STATE OF NORTH CAROLINA
DEPARTMENT OF TRANSPORTATION

Subject: Modification Request for the Individual Section 404 Permit, Individual Water Quality Certification, and Tar-Pamilico Buffer Authorization for the Rocky Mount Northern Connector, from SR 1604 (Hunter Hill Road) to US 301, Nash County, TIP No. R-2823, Debit \$570 from WBS 34509.1.1.

In an application dated December 17, 2008, the North Carolina Department of Transportation (NCDOT) submitted an Individual Permit application for the Subject project. This application requested authorization for impacts to jurisdictional features based upon a final design prior to an additional public meeting presenting the final design, held on October 28, 2008. Based upon comments from the meeting and subsequent inquiries from the public concerning the traffic flow from Station -L- 27+45 to Station 65+55, the roadway was re-designed to include directional crossovers and four bulb U-turns to provide additional left-turn traffic flow along Woodruff Road. The redesign will result in unavoidable impacts to Waters of the U.S. Revised permit drawings, buffer drawings and roadway plans are included with this modification request.

PROJECT REFERENCE NO.		SHEET NO.	
R-2823		23	
RW SHEET NO.			
ROADWAY DESIGN ENGINEER		HYDRAULICS ENGINEER	
REVISED 06/11/09 PERMIT DRAWING SHEET 62 OF 68

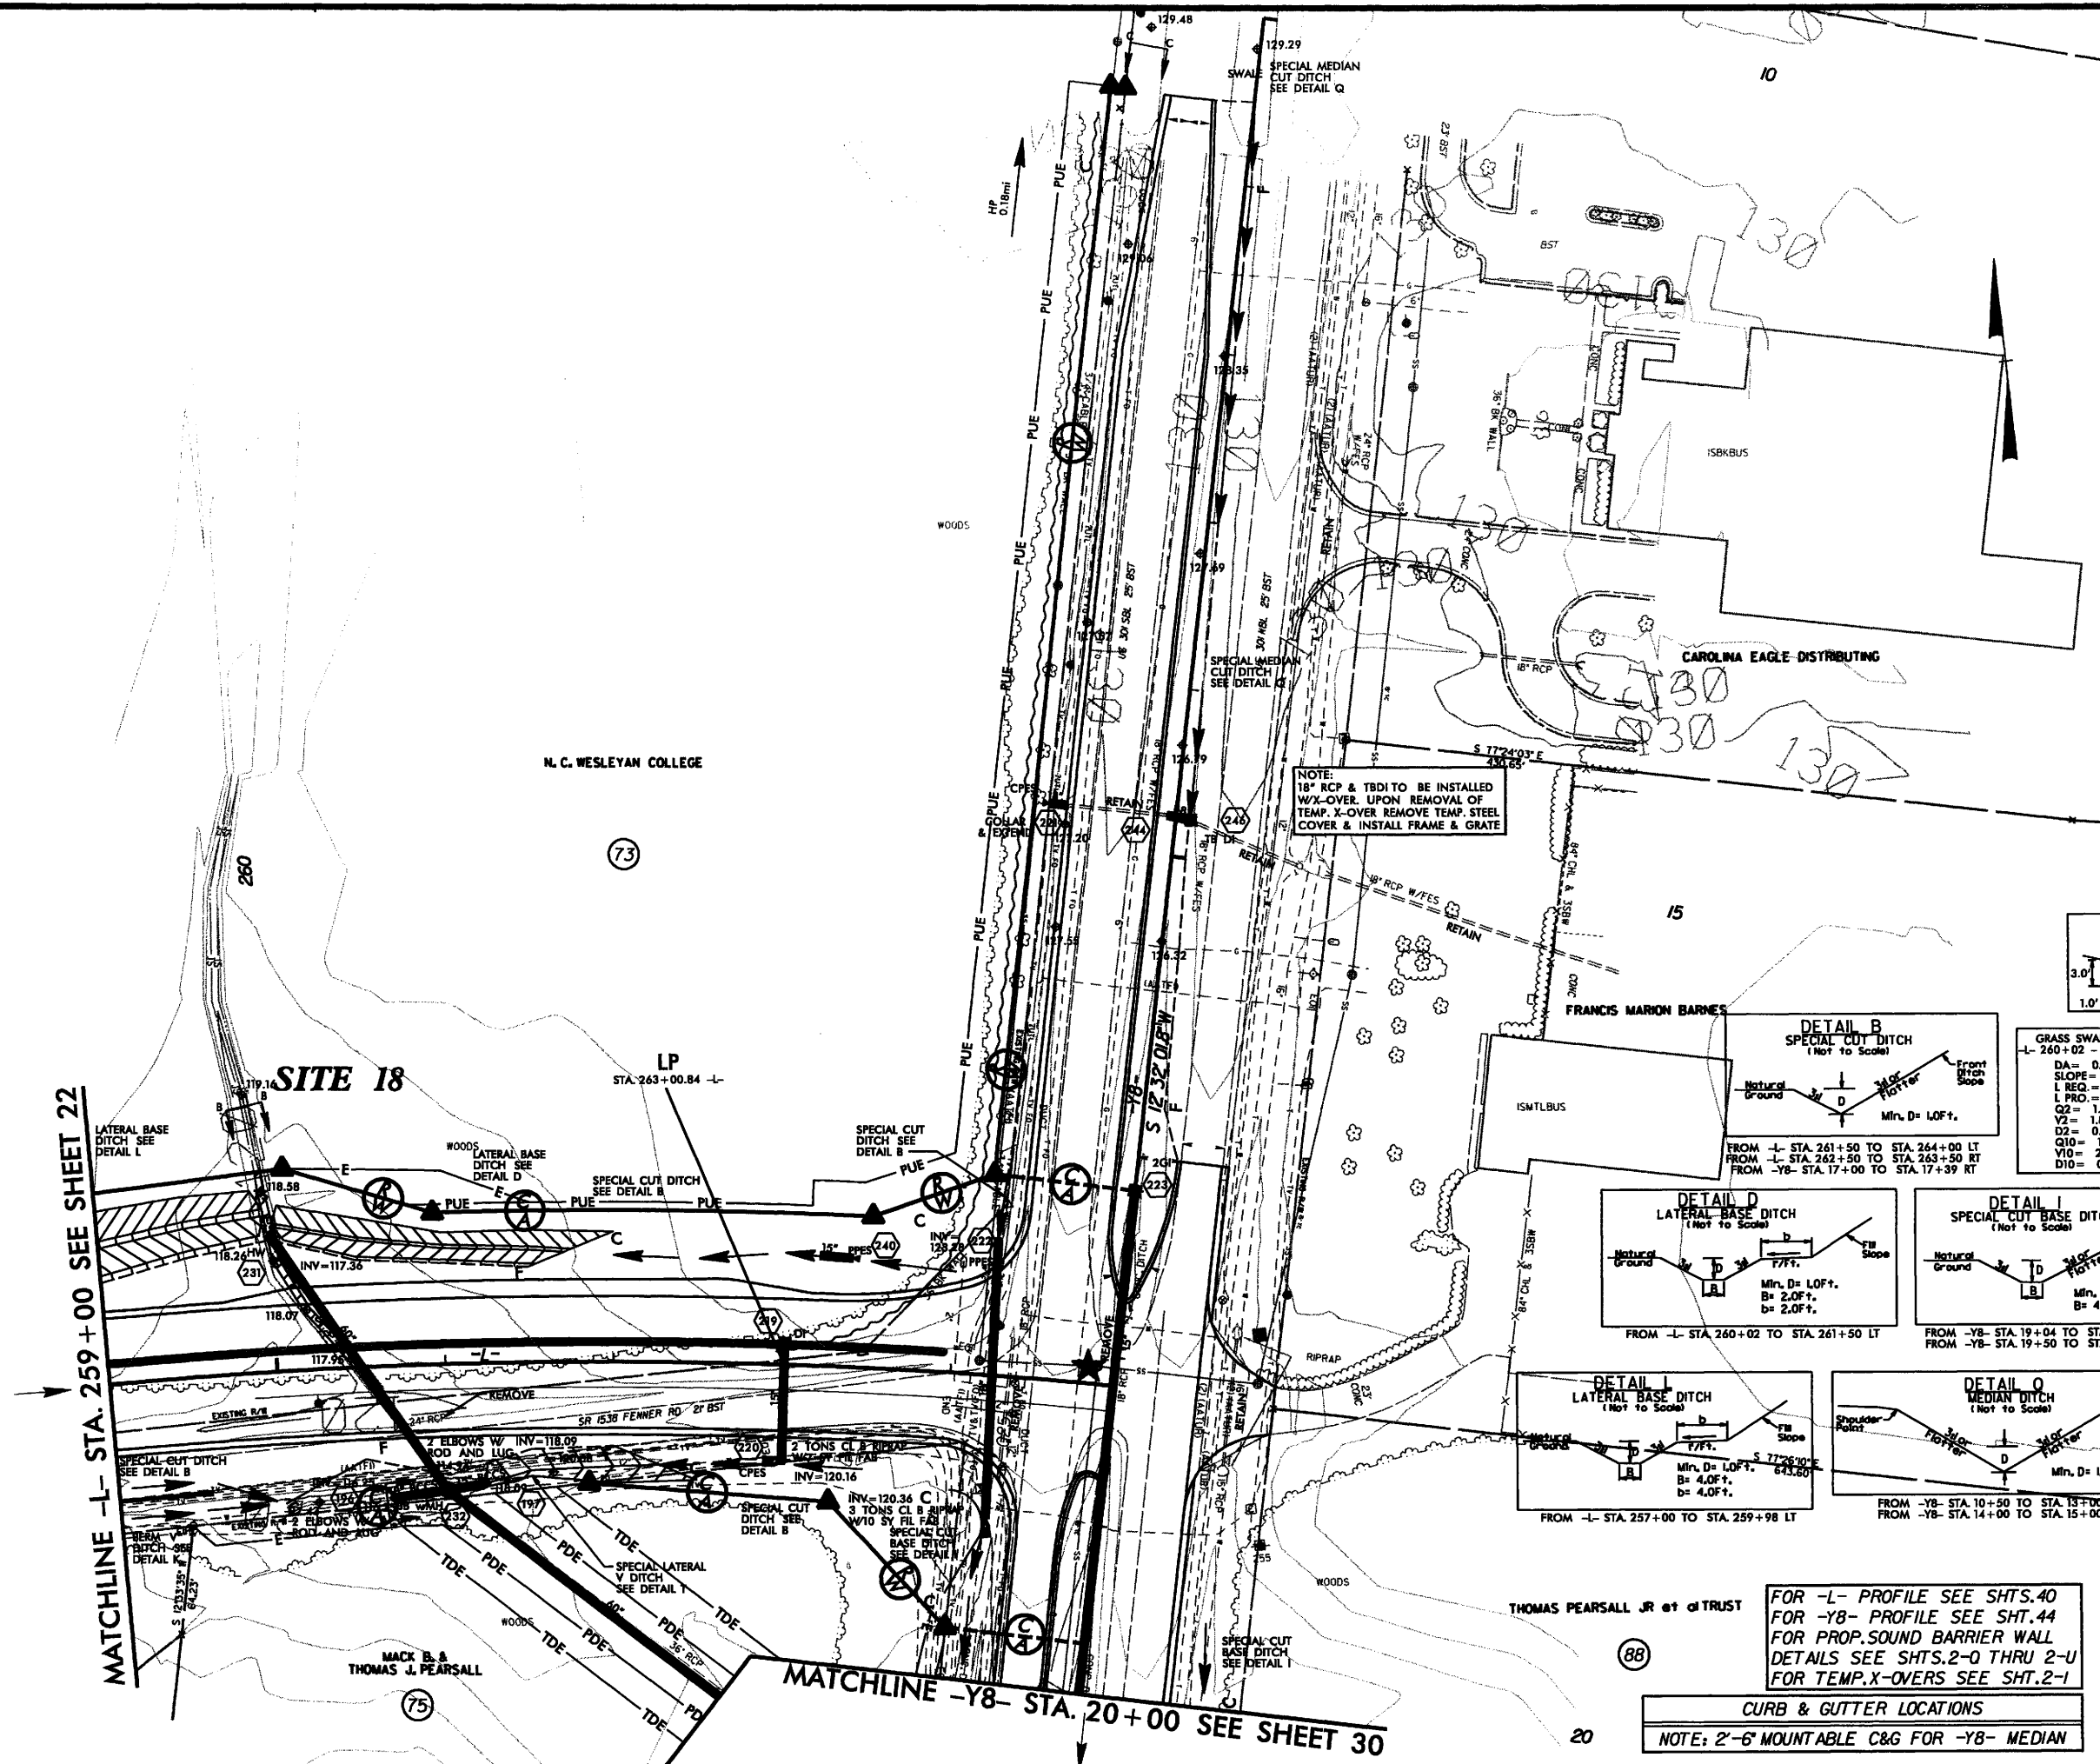
- Permit Drawing Sheets 19 and 20 of 68 show visual changes due to the addition of a bulb.
- Permit Drawing Sheets 62 and 63 of 68 have visual changes due to a couple new ditches required due to pipe clearance issues. (-L- Sta. 261+22 - 263+01 RT and -Y8- Sta. 17+00 - 17+39 and 19+04 - 20+00 RT)

SITE 1
REVISED 06/11/09
BUFFER DRAWING
SHEET 9 OF 56

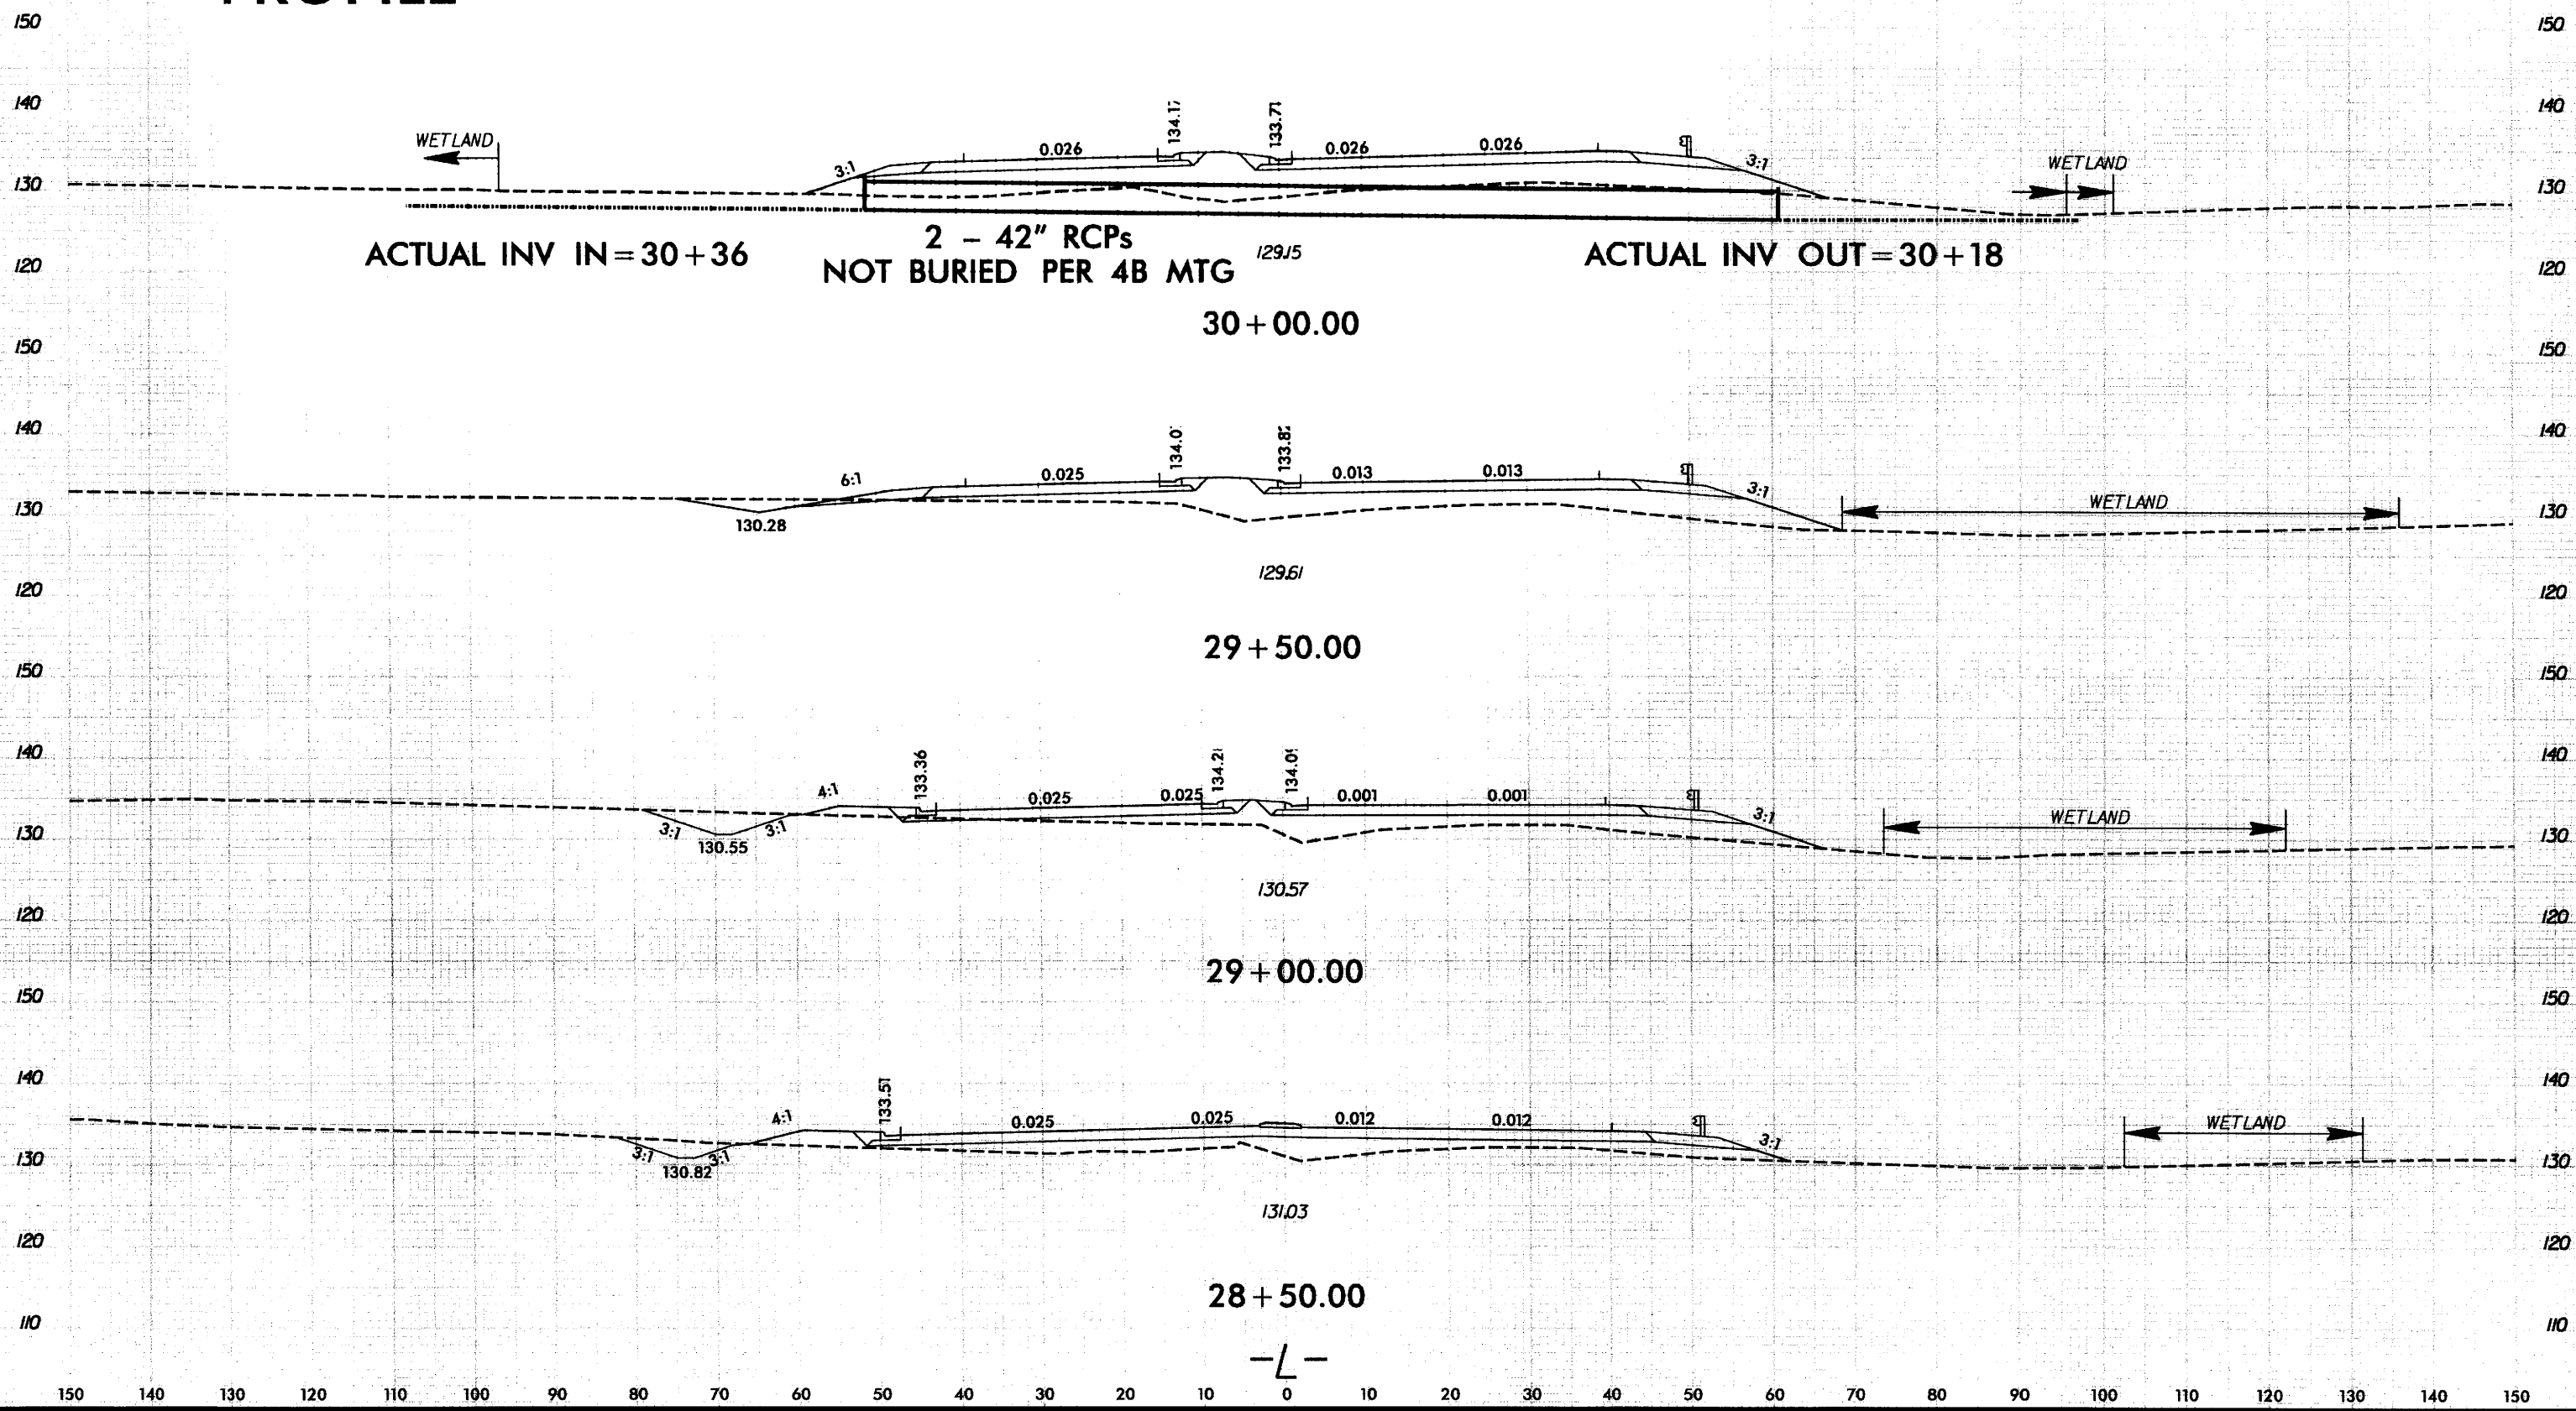
Revised cross section permit sheets 9 and 10 of 68 (buffer sheets 9 and 10 of 56) are enclosed.

REVISED 06/11/09
BUFFER DRAWING
SHEET 15 OF 56

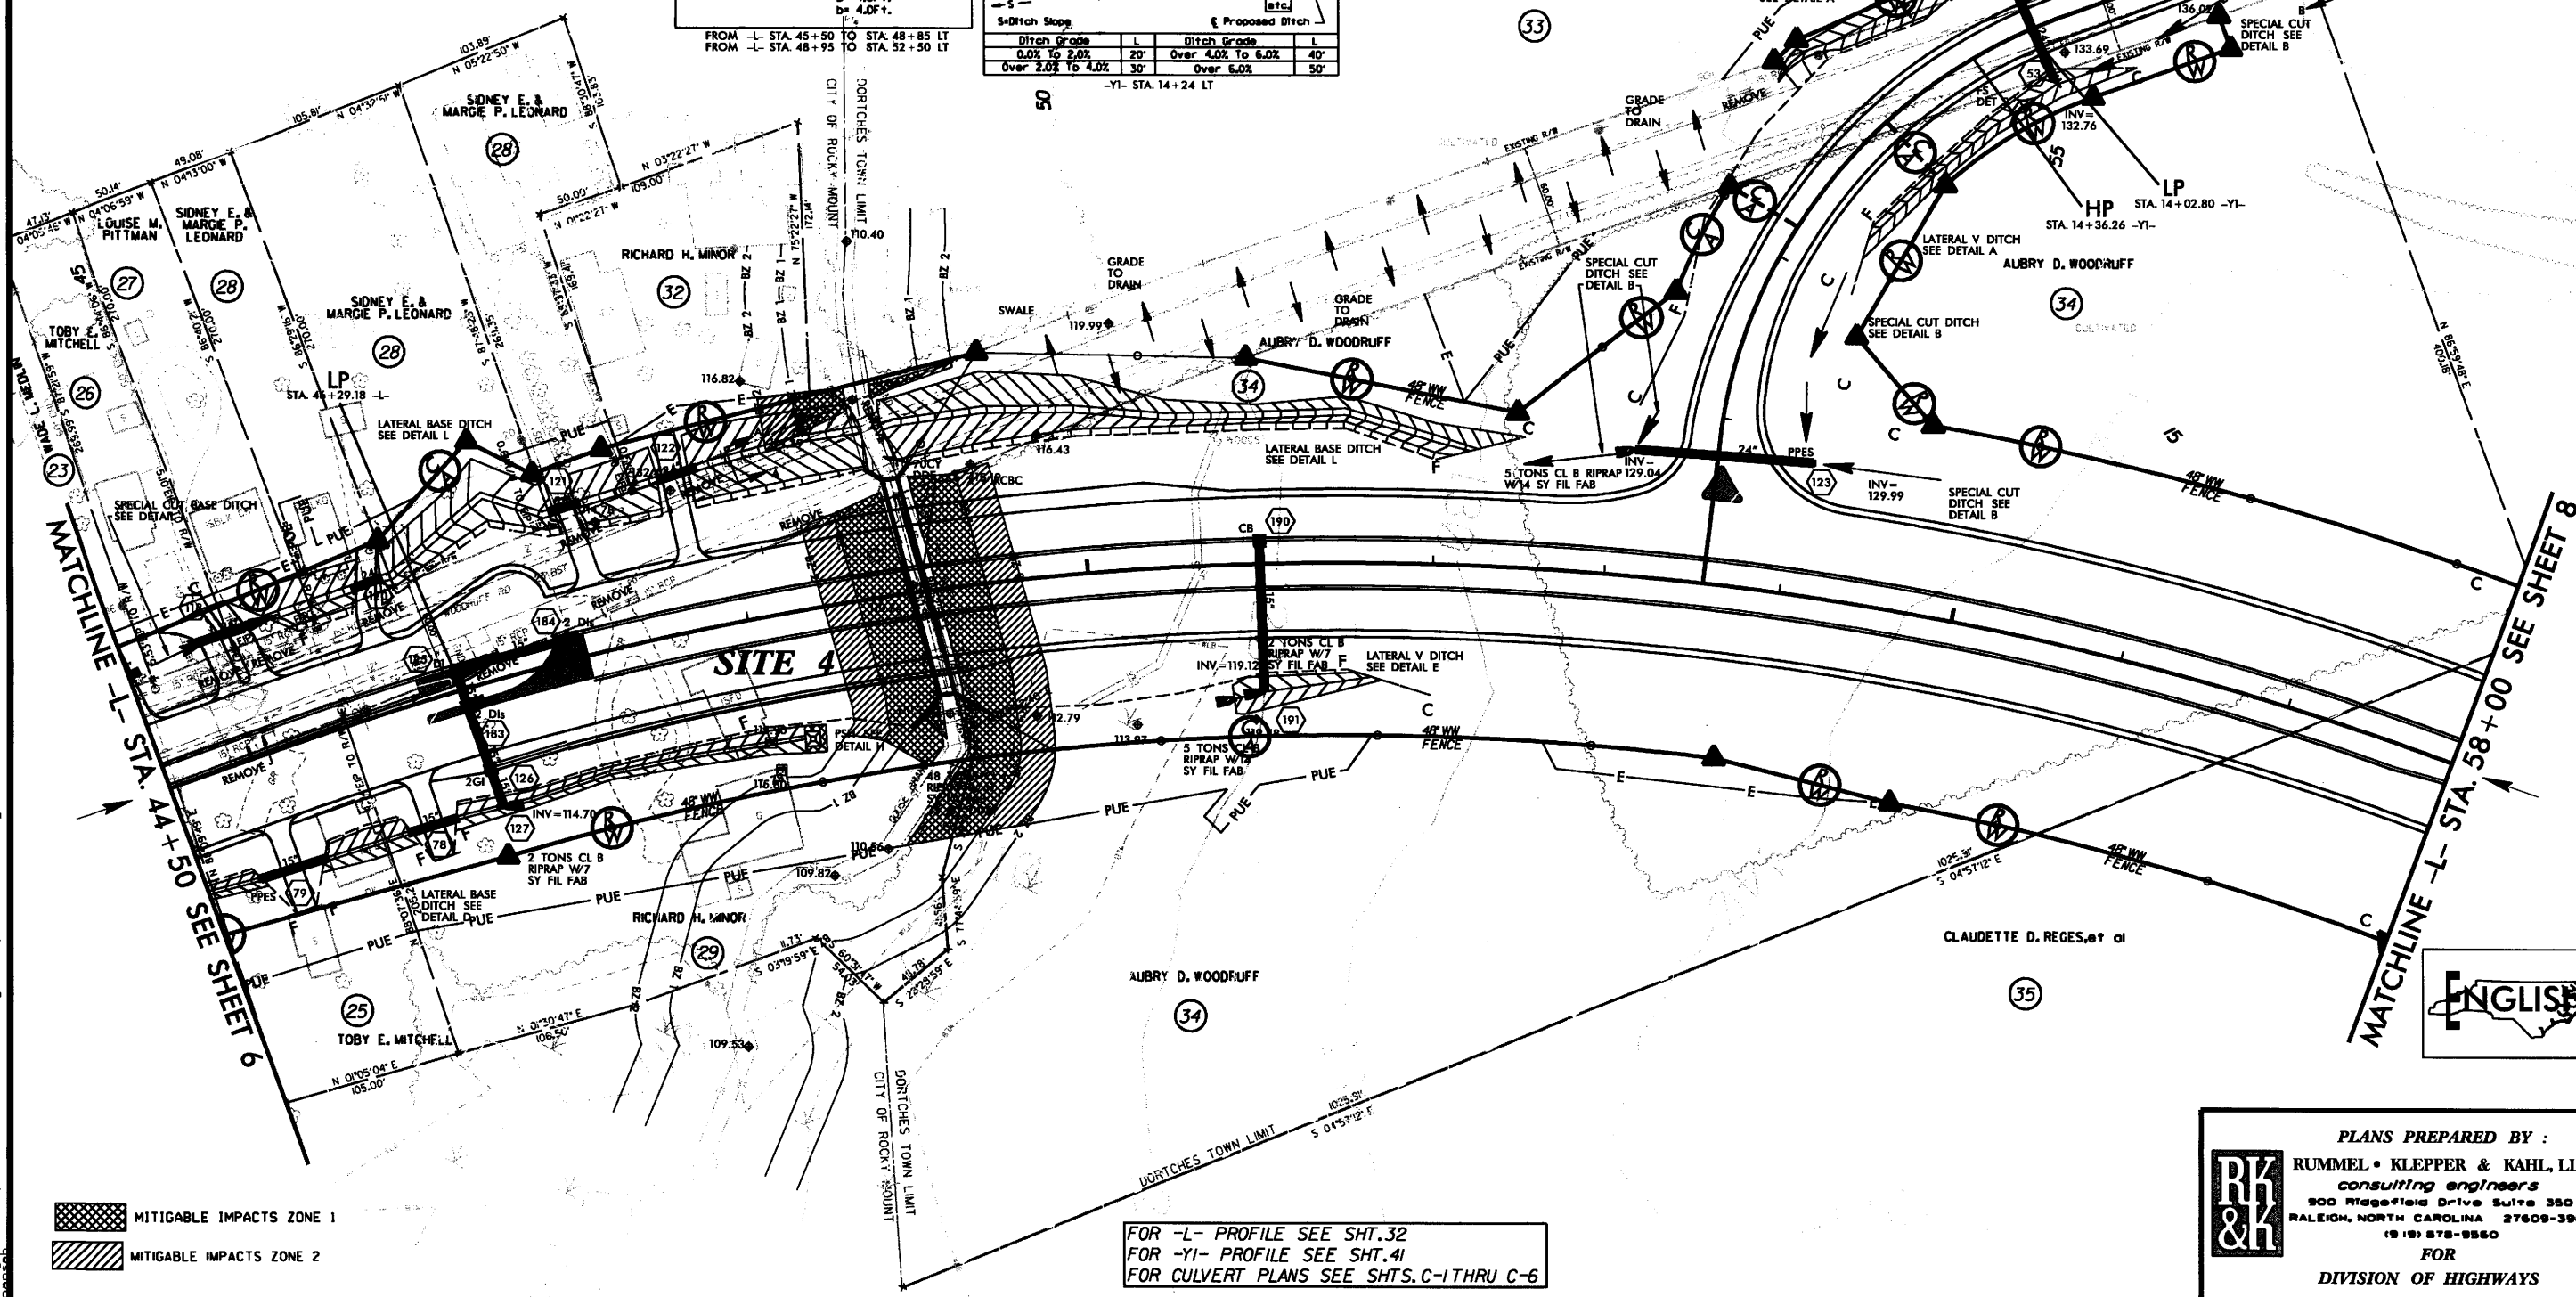
The revised drawings (Permit Sheets 14 and 15 of 68 and Buffer Sheets 15 and 16 of 56) indicate that impacts at Site 4 will change due to aerial utility lines. The sheets have also been revised due to a new bulb which does not have an impact on the environmental features. A summary of the original and revised impacts is provided in the following table.

The revised drawings (Permit Sheets 14 and 15 of 68 and Buffer Sheets 15 and 16 of 56) indicate that impacts at Site 5 will change due to aerial utility lines. The sheets have also been revised due to a new bulb which does not have an impact on the environmental features. A summary of the original and revised impacts at Site 5 is provided in the following table.

Impact Description	Dec. 17, 2008 Impact	Revised Impact	Impact Change
Perm. Surface Water Impacts	0.04 Ac (158 LF)	0.04 Ac (158 LF)	None
Temp. Surface Water Impacts	0.01 Ac (54 LF)	0.01 Ac (54 LF)	None
Wetlands in Buffer Zone 1	41 sq ft	168 sq ft	+127 sq ft
Wetlands in Buffer Zone 2	574 sq ft	1,712 sq ft	+1,138 sq ft
Mitigable Buffer Zone 1	10,527 sq ft	11,823 sq ft	+1,296 sq ft
Mitigable Buffer Zone 2	6,437 sq ft	7,647 sq ft	+1,210 sq ft
